STAFF REPORT 10-09-2019 REGULAR MEETING

APPLICATION NUMBER: 19-6450

ADDRESS: 14655 ROSEMONT AVENUE

SCOPE: DEMOLISH EXISTING GARAGE, CONSTRUCT NEW GARAGE

FRONT ELEVATION
 SCALE: $\frac{1}{4}'' =$

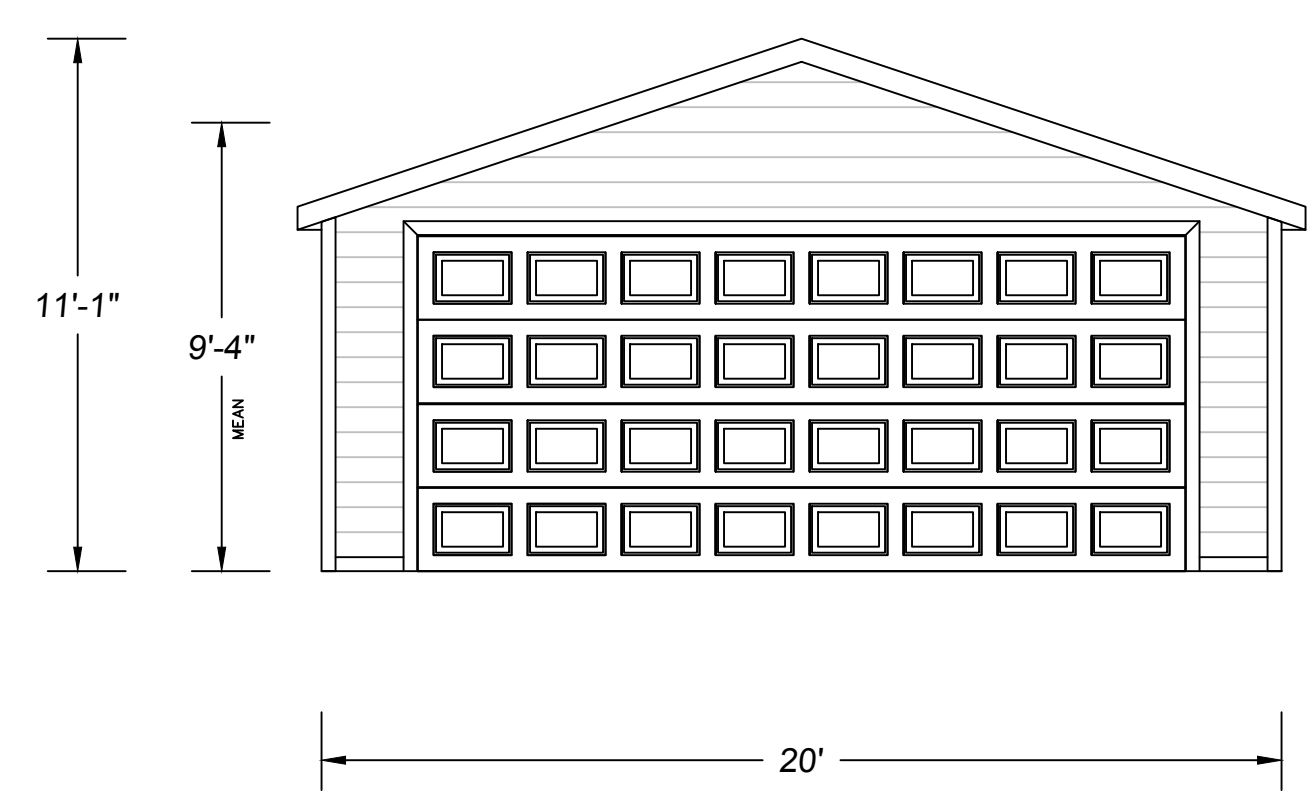
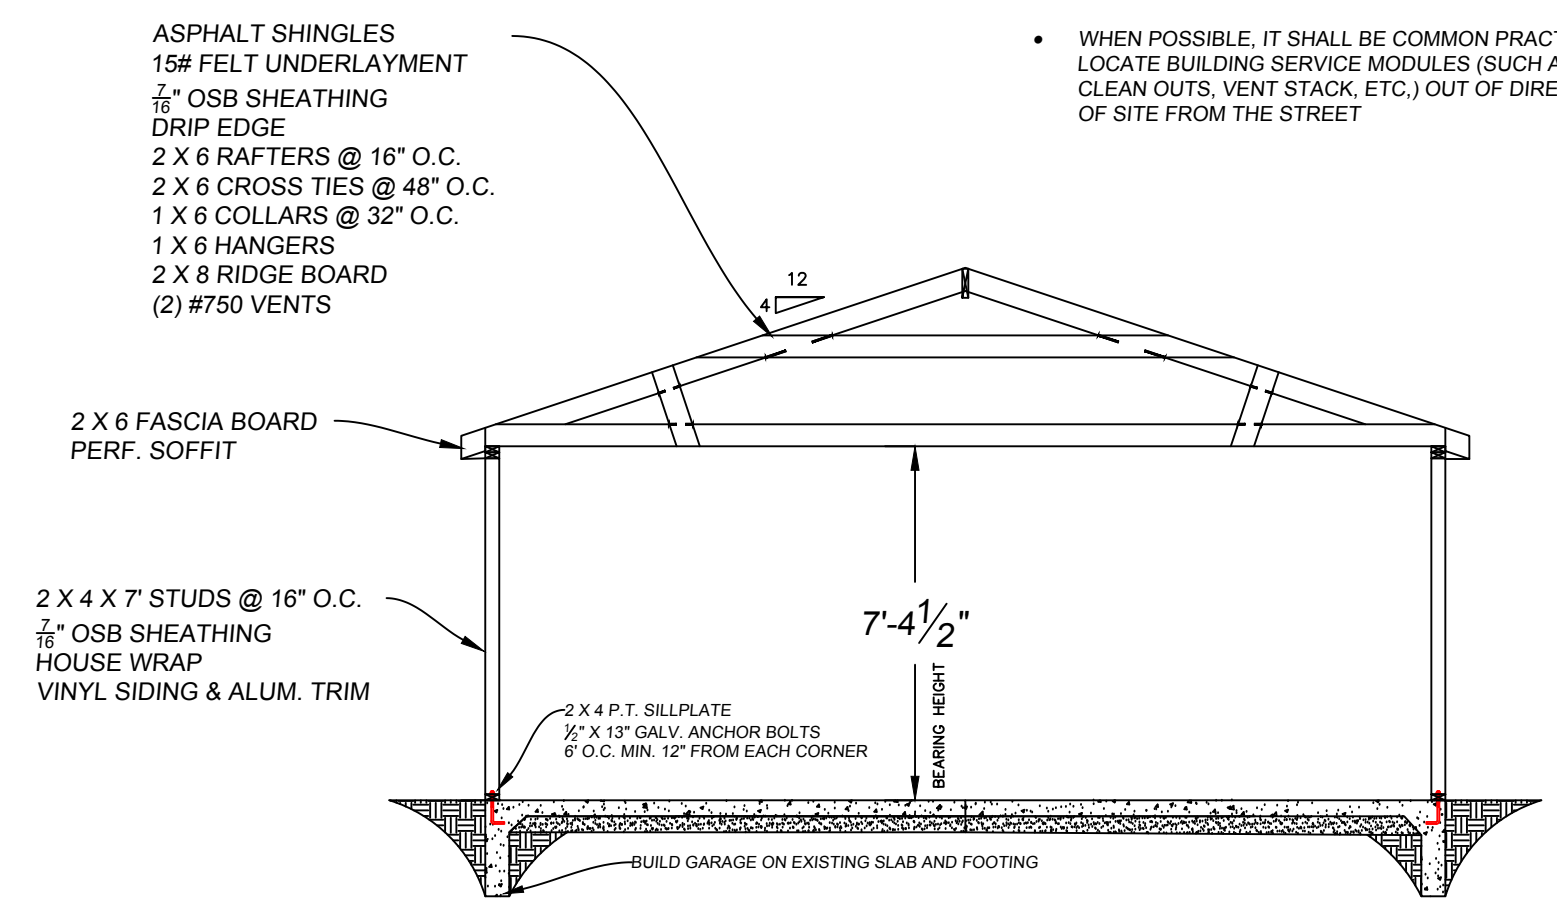
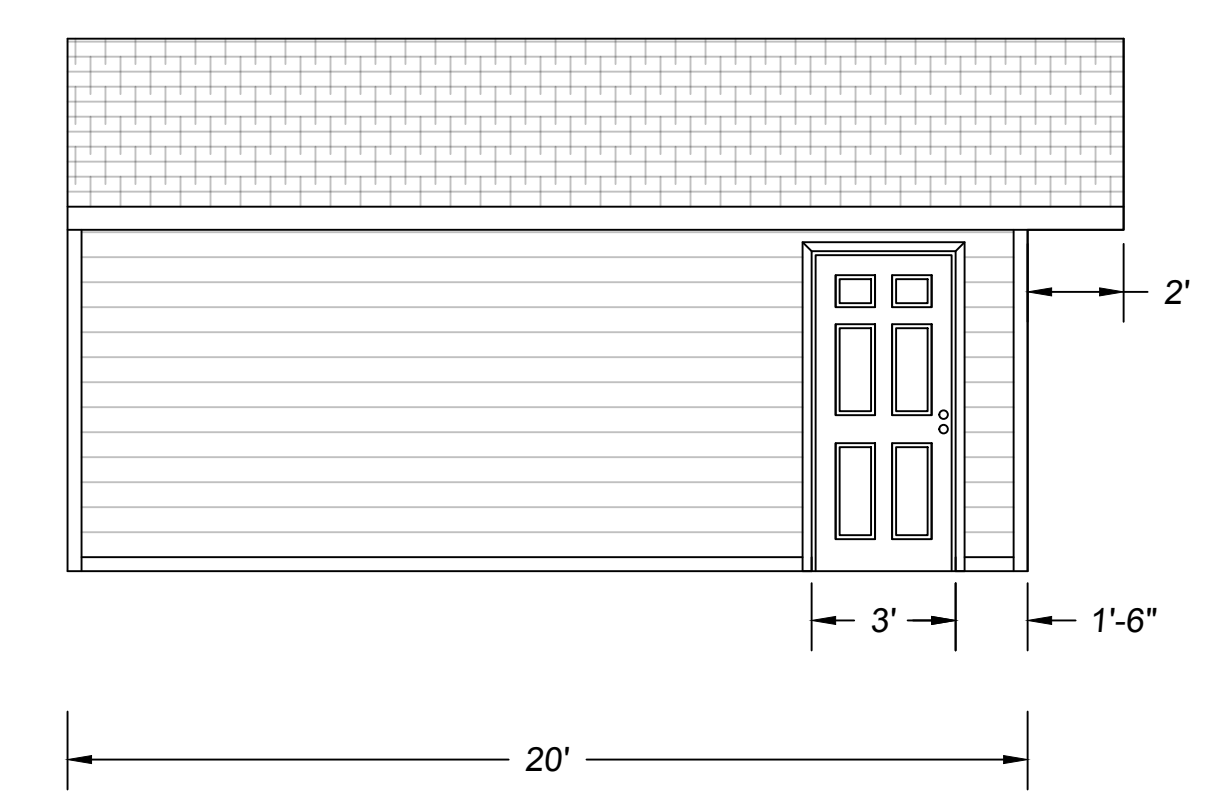
- The proposal for the new garage includes vinyl siding. Vinyl is not considered an appropriate material within historic districts.

- The siding at the new garage be a painted lapped wood or Hardie board siding rather than vinyl.
